Sydney Metro Northwest: Bella Vista Station Precinct Concept State Significant Development Application (SSD 10344)

Response to Submissions Report

Applicable to:	Bella Vista Station Precinct, Sydney Metro Northwest
Author:	GLN Planning
Owner	Sydney Metro
Status:	Final
Version:	04
Date of issue:	July 2020
Review date:	July 2020
© Sydney Metro 2020

Figure 4: EIS Ground Floor Setbacks (left) and as amended by the RtS (right)

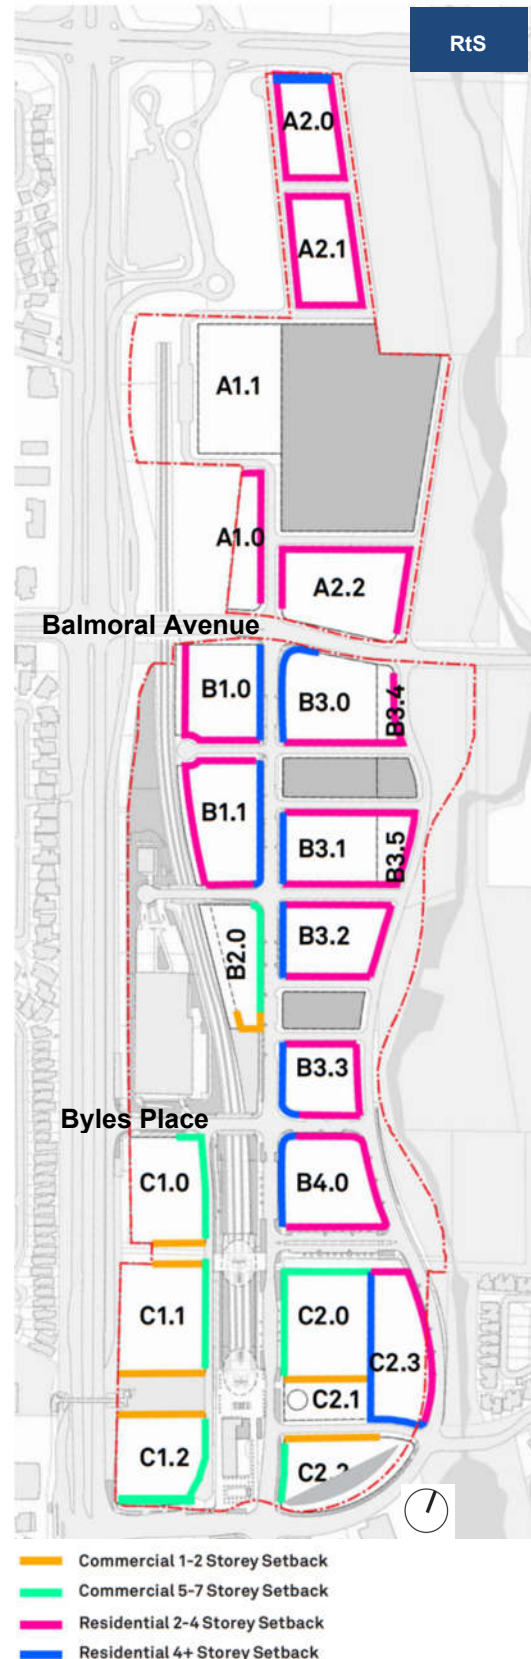
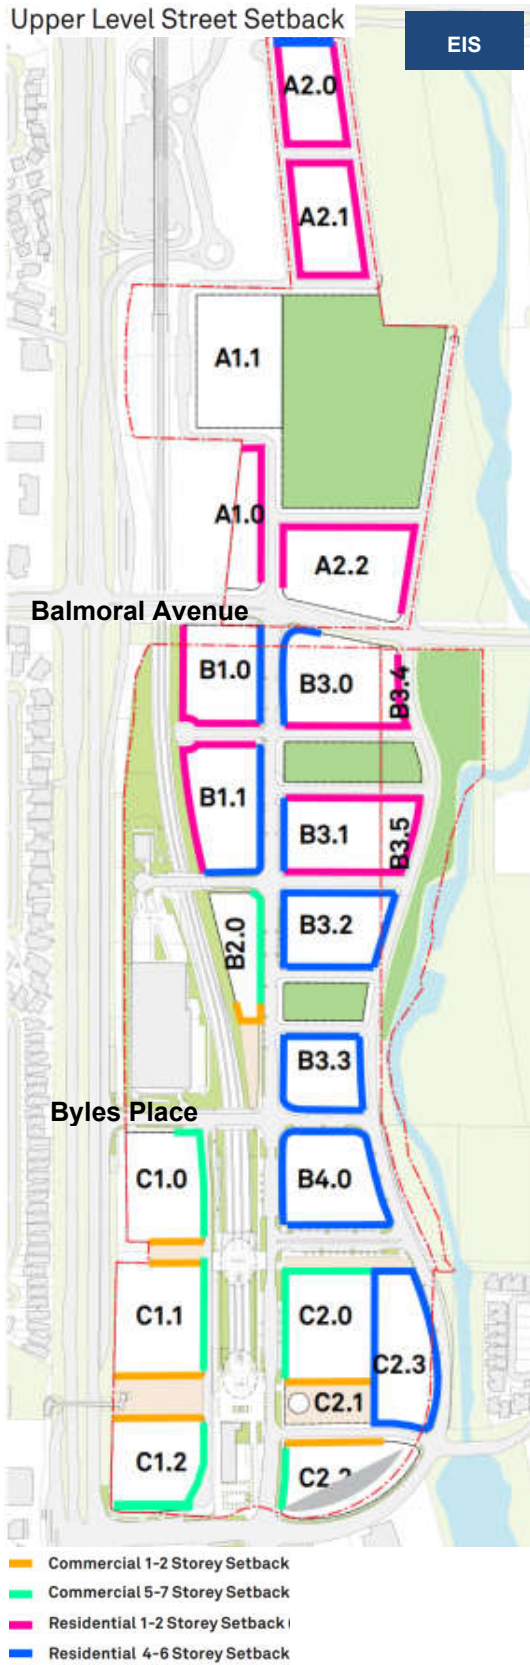
<ul style="list-style-type: none"> • Provide further justification/assessment for the proposed clause 4.6 variation to the building setbacks in relation to built form outcomes including delineation of the public/private interface, residential amenity, 	<p>A revised clause 4.6 variation to the amended building setback regime is provided at Appendix K.</p> <p>As noted above, the setback scheme has been revised to require deeper setbacks along the northern and southern block frontages to the east of Mawson Avenue. Context</p>	<p>Refer Appendix A, B and K</p>

The original and revised ground floor setbacks are provided side by side in Figure 4. The original and revised upper floor setbacks are provided side by side in Figure 5.

Figure 10: EIS Building Envelopes in Residential Core and Local Hub (red outlines)

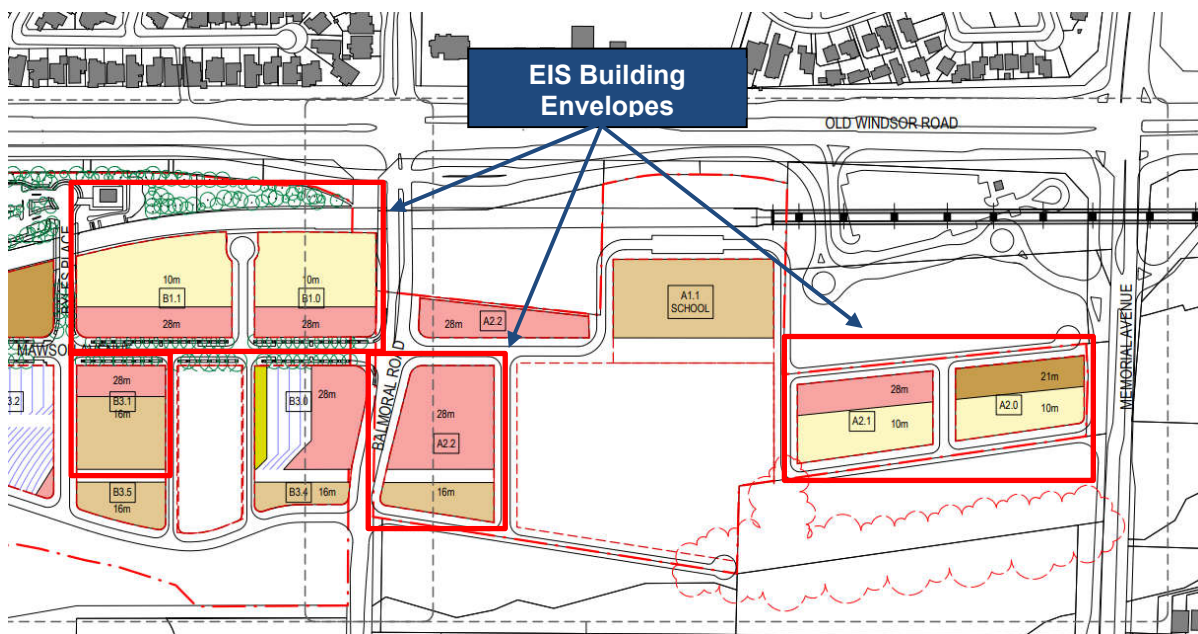
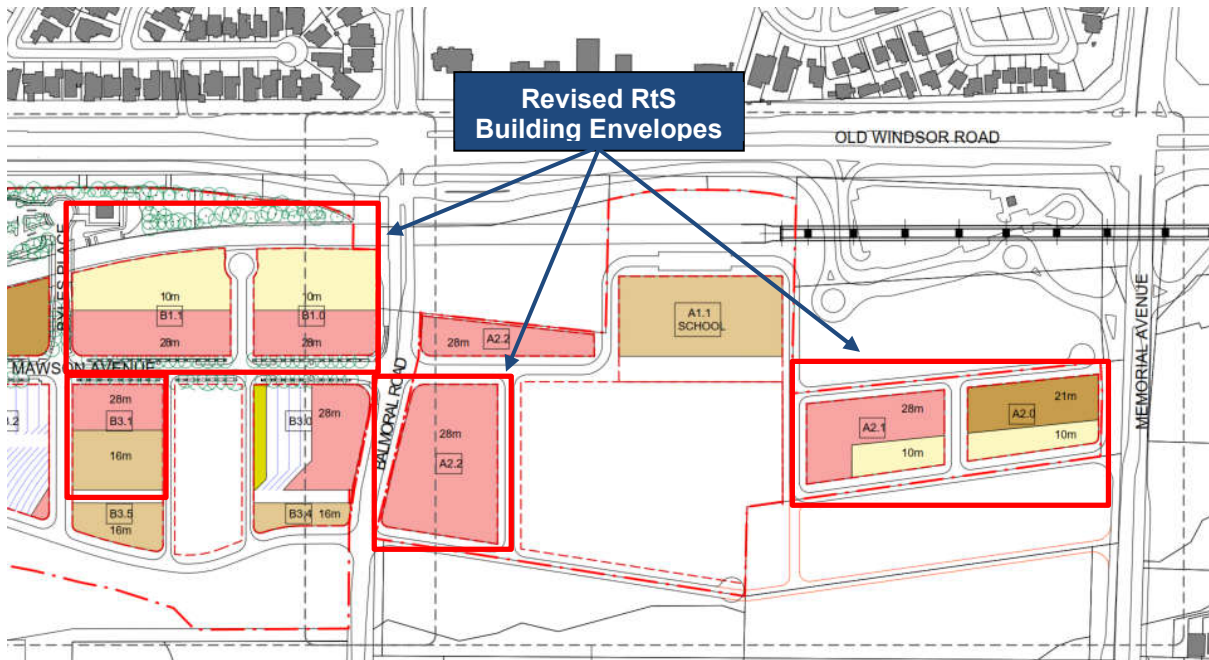
Figure 10 shows the building envelopes north of Byles Place proposed under the EIS. Figure 11 shows the revised building envelopes sought under this RtS. The key changes to the scheme and the Plans for Approval include:

- Increased depth of the 21m height zone on Lot A2.0 from 24m to 35m to focus future built form toward the local road.
- Increased depth of the 28m height zone on Lots A2.1, B1.0, B1.1 and B3.3 from 24m to 35m and extending this zone to facilitate a consistent height frontage towards the district open space and promote built form along Mawson Avenue.
- Consolidation of Lot A2.2 to provide 28m over the entire lot with north to south laneway.

Figure 16: Shadow Diagram during the Winter Solstice – 3PM

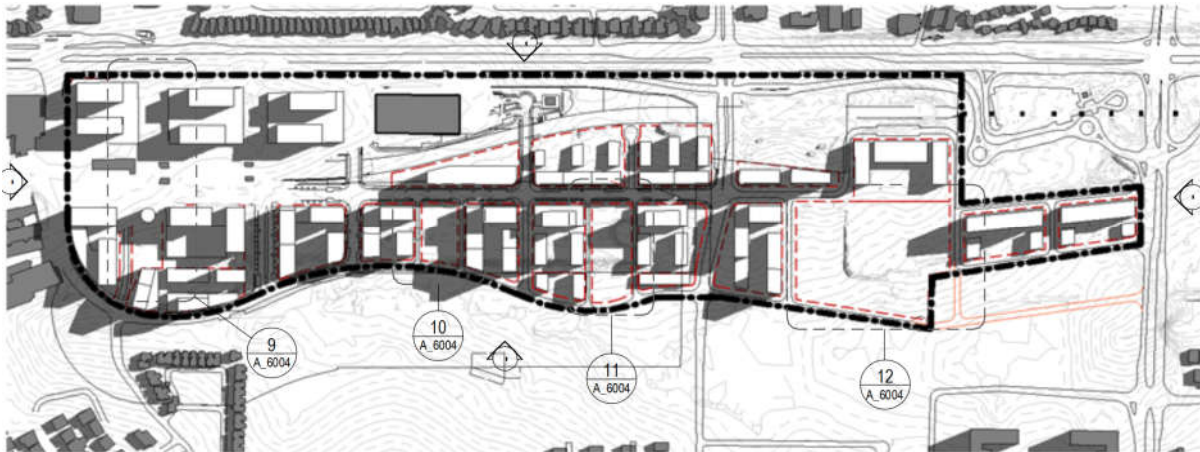
<ul style="list-style-type: none"> Provide additional shadow analysis for the Bella Vista Station Precinct to demonstrate that appropriate solar 	<p>A revised shadow analysis and solar access study has been prepared for the revised reference scheme and is included in the relevant plans for approval at Appendix B of the</p>	<p>Refer Appendix A and B</p>

Figure 16 shows the shadow impacts at 3PM during the winter solstice. The largest off-site overshadowing is associated with development blocks C1.2, C2.2 and C2.3 in the commercial core. Additional shadows associated with these sites have the potential to fall onto existing office buildings in the Norwest Business Park. Small areas of additional shadow are also predicted to occur from development blocks B3.2 and A2.2.

Additional shadows from these sites would fall into Elizabeth Macarthur Creek and would not impact the amenity of any nearby residential dwelling. Predicted shadows from development block A2.1 would fall onto the district open space.

Figure 18: Development Footprint Overlay with Riparian Corridor Encroachments

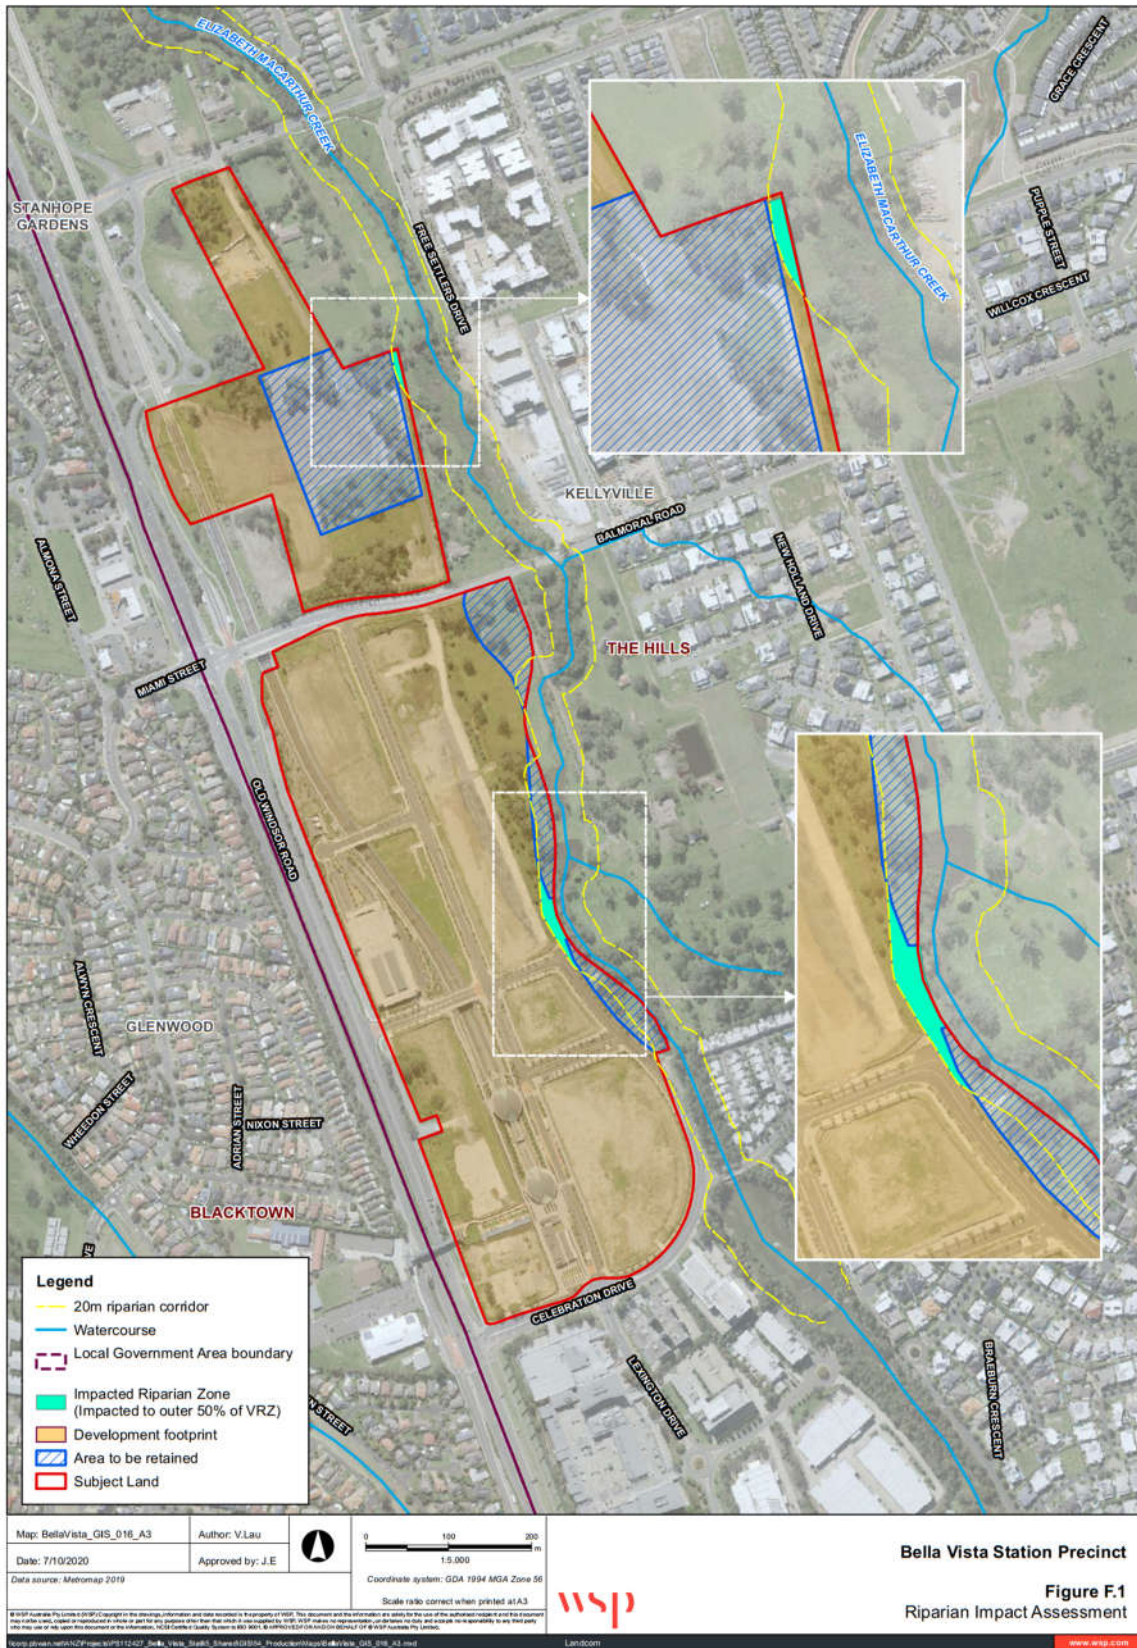
<p><u>Riparian Assessment</u></p> <ul style="list-style-type: none"> A riparian assessment for the Bella Vista Station Precinct should be submitted, similar to that provided for Kellyville. 	<p>WSP has prepared a riparian assessment, which forms part of the revised BDAR at Appendix H of this RtS. Mitigation measures have been revised to reflect those specified in the Riparian Assessment accompanying SSD-10343 for the Kellyville Station Precinct prepared by WSP.</p> <p>Figure F1 of the riparian assessment provides an overlay of the 0.17ha encroachment of the Bella Vista concept SSDA site within the outer 50% of the Elizabeth Macarthur Creek Riparian Corridor (refer to Section 2.5.2). These encroachments are located at:</p> <ul style="list-style-type: none"> The proposed turning circle at the north eastern corner of the district open space The corner of Celebration Drive and Florey Avenue associated with the existing road reserve constructed under SSD-5414 The south eastern corner of Lot B4.0 at the interface of the extension of Celebration Drive. <p>It is considered these minor enhancements can be offset through the averaging rule along the riparian corridor and a land based offset is not necessary.</p>	<p>Refer Appendix H</p>

In response to THSC's request in their submission, WSP has prepared a riparian assessment for the Bella Vista Station Precinct. The assessment is provided at Appendix F of the updated BDAR contained at Appendix H. The assessment identified the concept SSDA site would encroach the vegetated riparian zone (**VRZ**) of Elizabeth Macarthur Creek in three locations, up to a total area of 0.17ha. The locations of the encroachment include:

The identified encroachments occur within the outer 50% riparian corridor and are detailed in Figure 18.
